**Re: Application for Site Plan Approval at 657 Saw Mill River Road  
(a/k/a Parcel No. 6.50-35 Lots 8, 9, 10, and 11)**

We are pleased to provide responses to the Village Consultant and NYSDOT review memorandums along with Board of Trustee and public comments. A digital copy of the full submission package will be provided to the Building Department via email. Accordingly, we have provided the below materials and responses for your consideration to be discussed at the next Town Board Meeting.

**MEMO from David B. Smith of Planning & Development Advisors –  
Site Plan Review 657 Saw Mill River Road  
December 12, 2023**

**PASSENGER VEHICLE TURNING ANALYSIS**

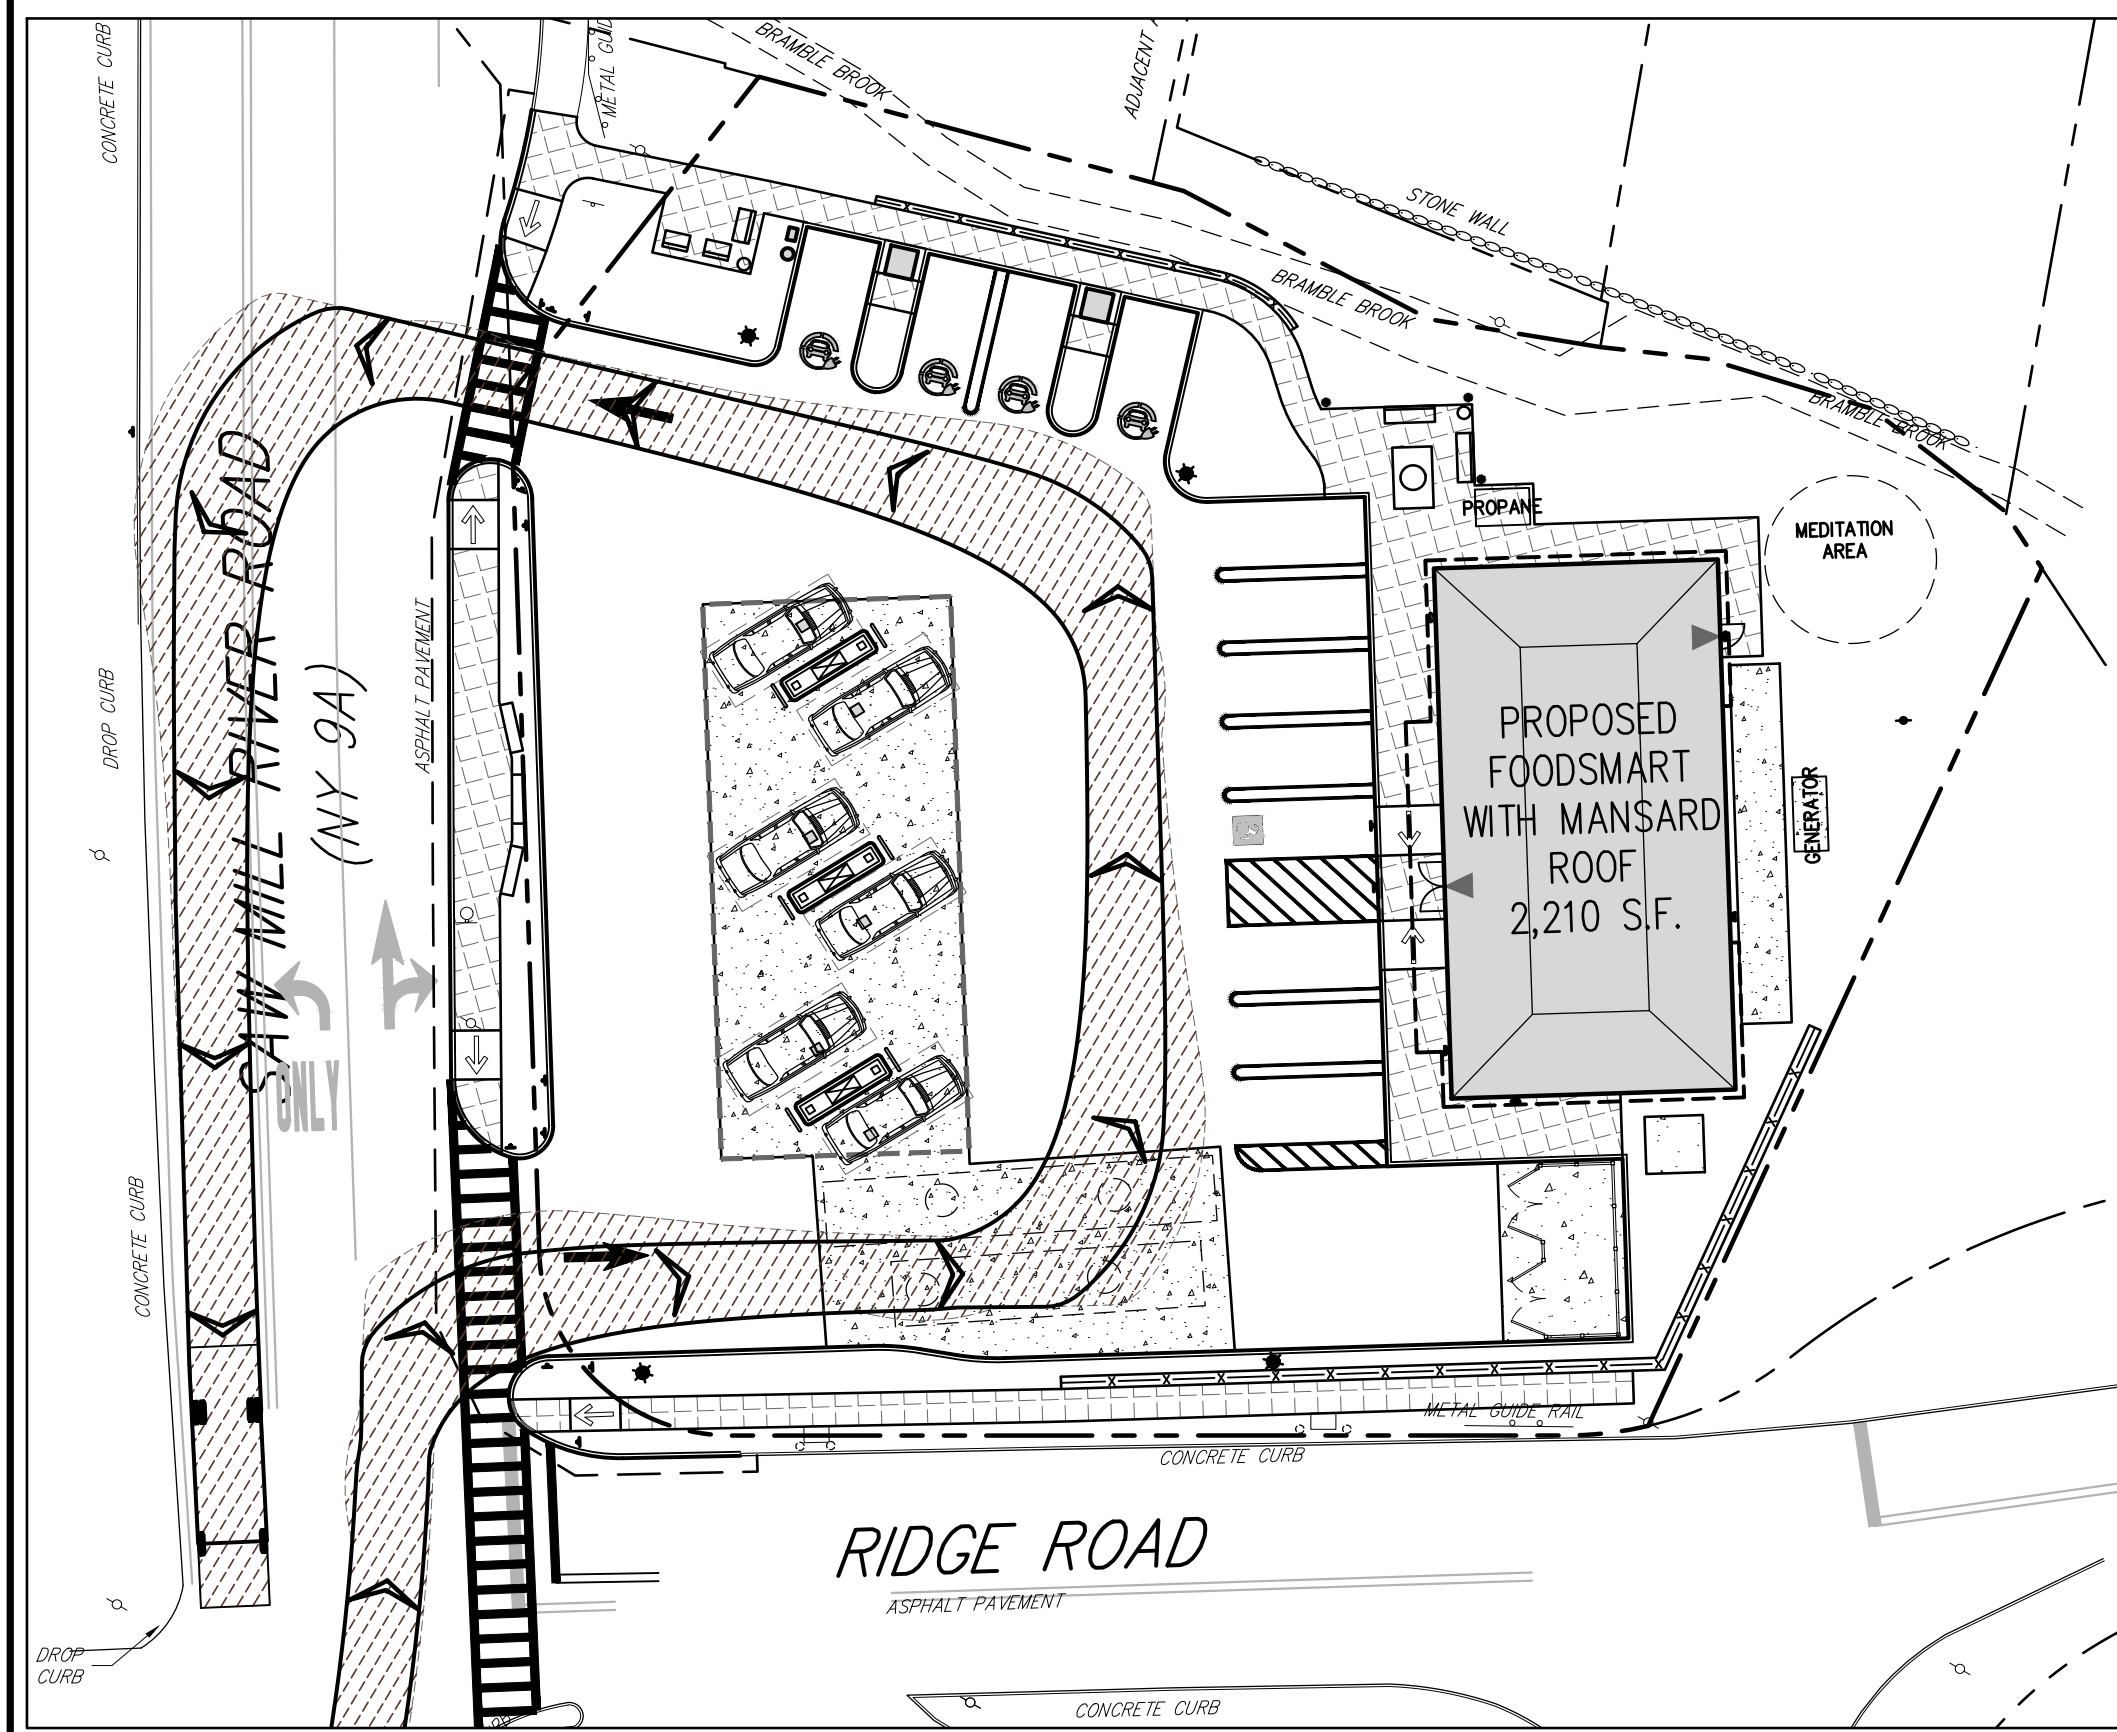
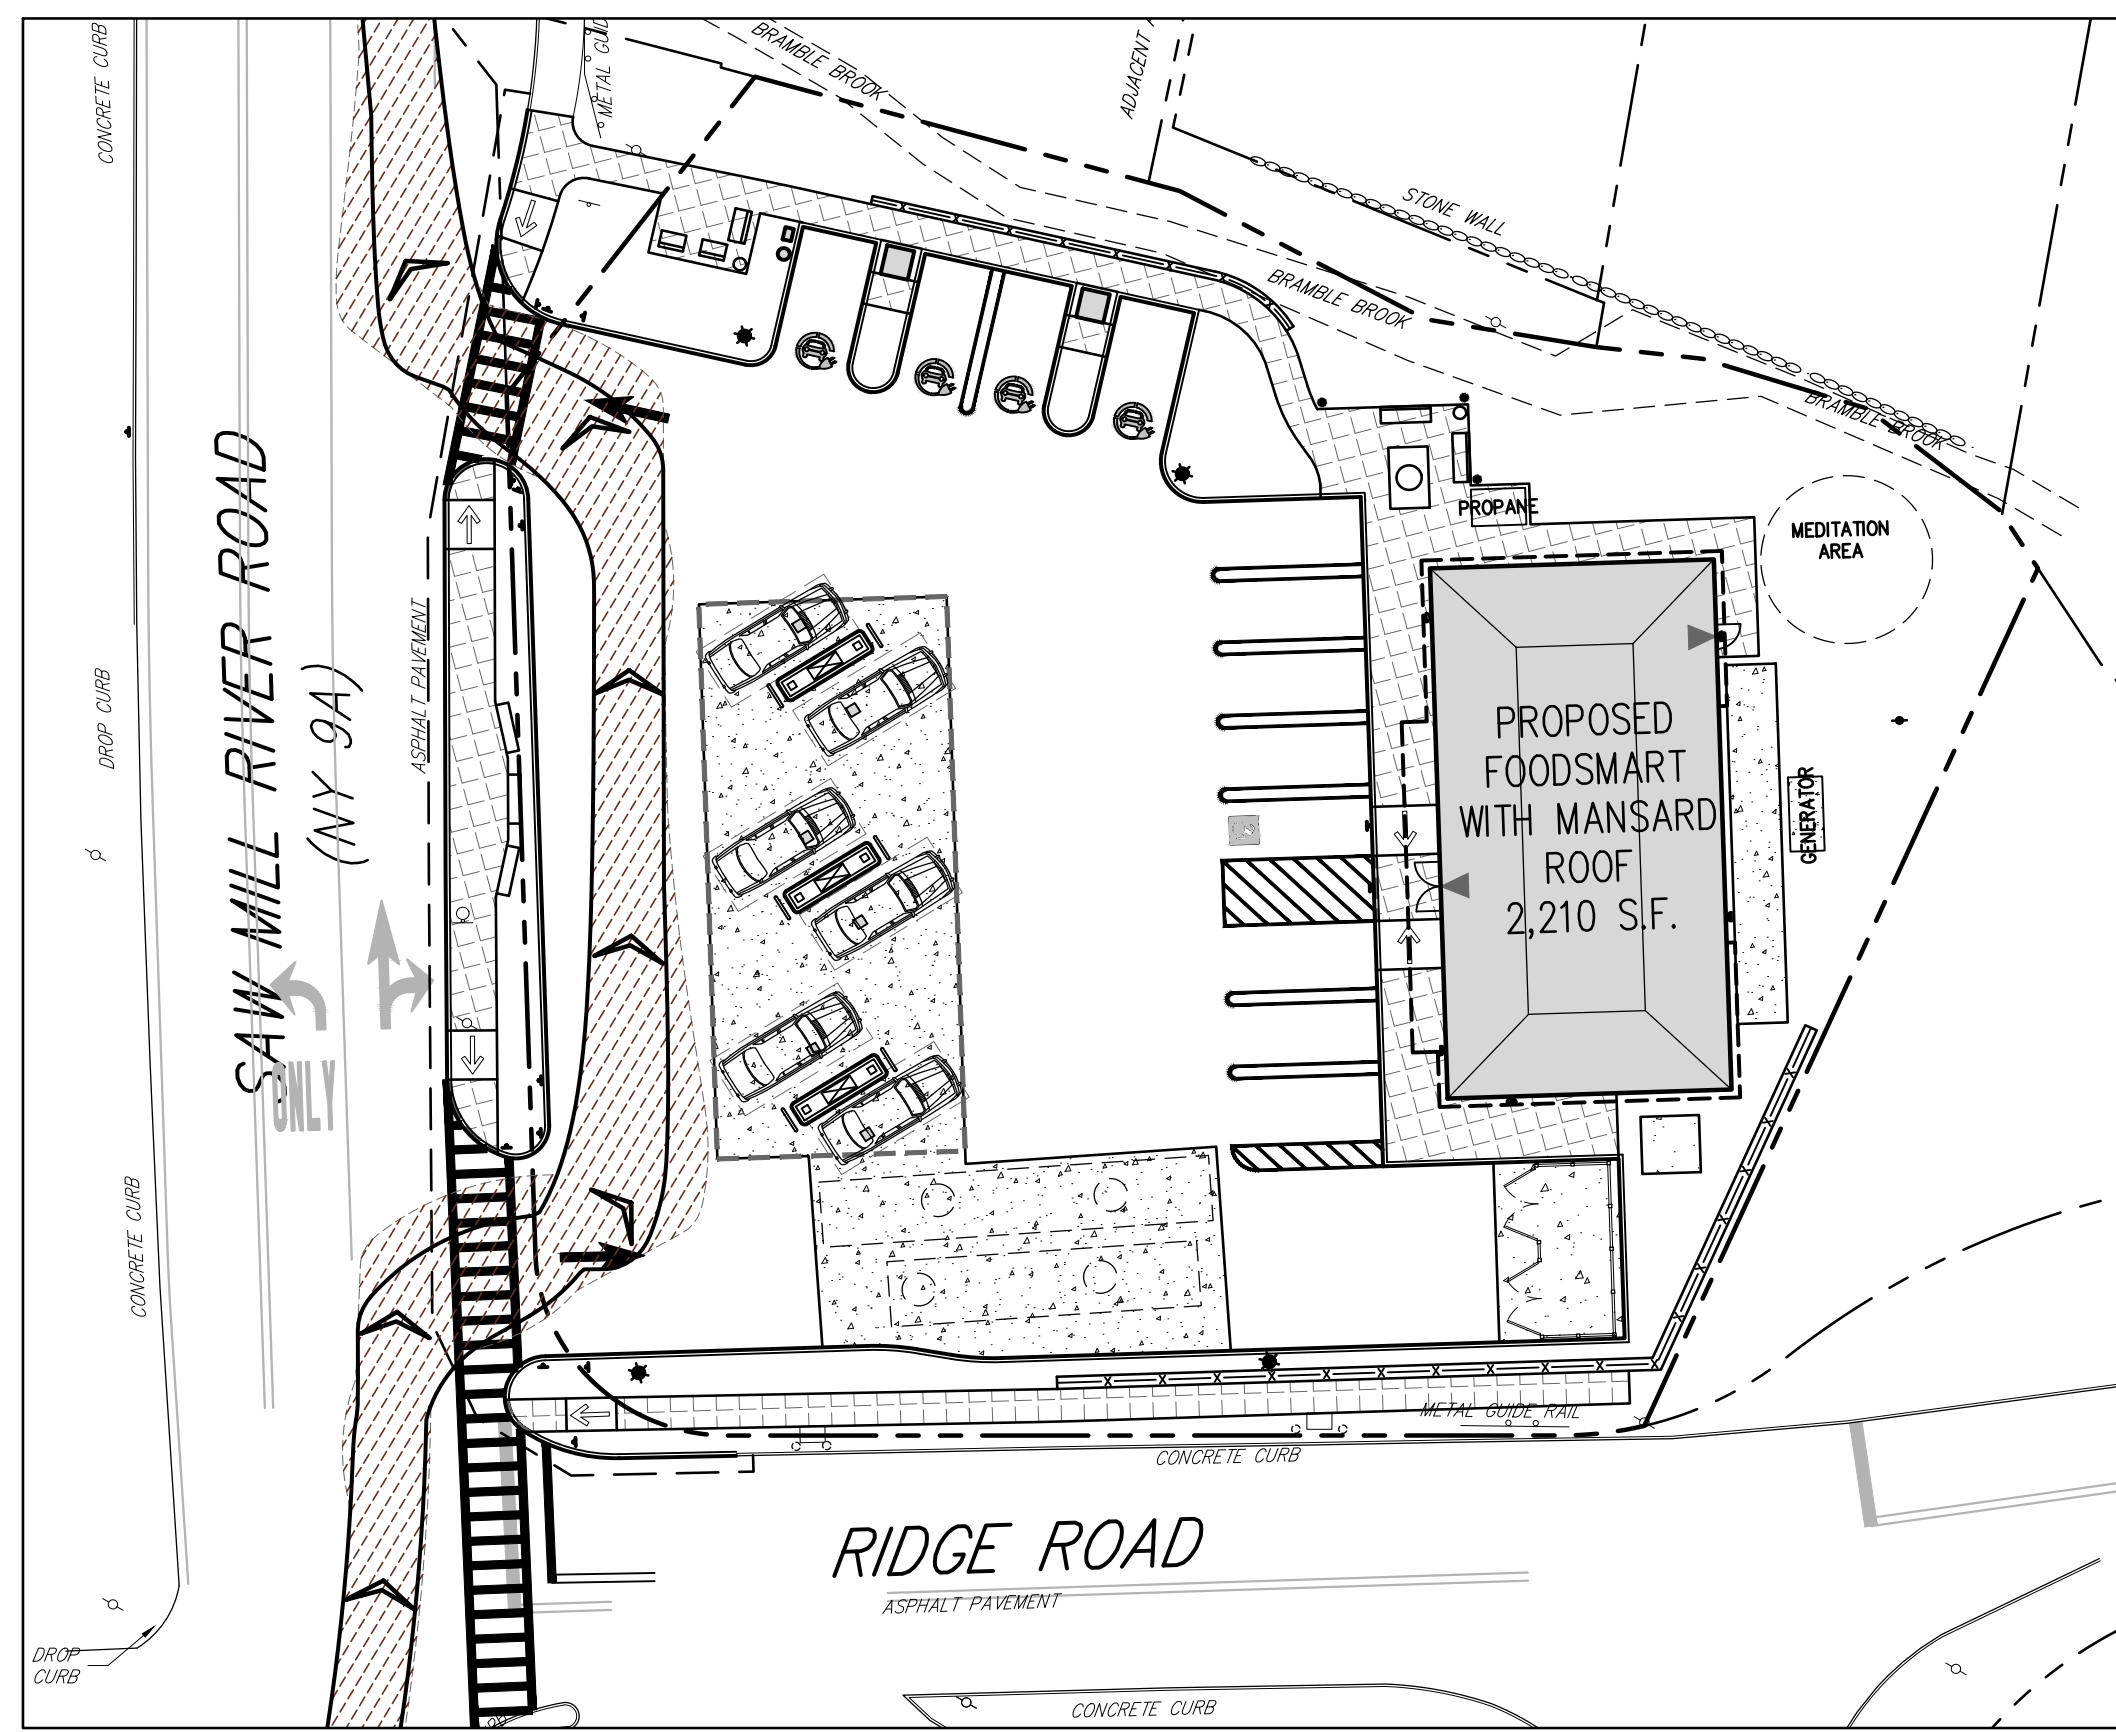
**Comment 1.** The applicant has prepared a Turning Analysis Plan, which examines the turning movements into and out of the property for passenger vehicles, tanker trucks and garbage trucks. The plan reflects interference with vehicles at the fuel pumps for tanker trucks entering the southern driveway from the south and exiting the northern driveway. The applicant should reexamine the southern entrance, in an effort to eliminate the present conflict between a tanker truck entering and a vehicle located at the most southern fuel dispenser. The applicant should also examine modifications to the site layout, which would permit tanker trucks exiting the property to avoid conflicts with a vehicle at the most northern fuel dispenser. It appears the

The Turning Analysis Plan also does not provide exit movements for vehicles utilizing the northern fuel island. The plan should be amended confirming that such a turning movement is obtainable.

Fuel Trucks - Drawing C-110 shows that a fuel truck coming from the south and turning into the southern driveway will have to drive over a portion of the sidewalk as well as on the paver section. This area is shown to be mountable but will they be able to support the weight of fully loaded fuel truck? The NYSDOT will also review this. It would be beneficial to have an employee present at the sidewalk to assist the fuel truck driver and to keep any pedestrians back due to the wide turn that has to be performed and the limited sidewalk length for someone who has just crossed Ridge Road.

The building has been pushed back as far as possible while still maintaining a 6' setback from the rear property line. The main drive aisle between the convenience market and the pumps has been widened by 10'. The southern driveway has been shifted south about 6.5', eliminating all previous conflicts. The need for a cobble stone paver infill and mountable curb has also been eliminated with this new proposed driveway location. Exit movements for vehicles utilizing the northern most fuel island have been added to JMC Drawing C-110 and a new JMC Drawing C-120.
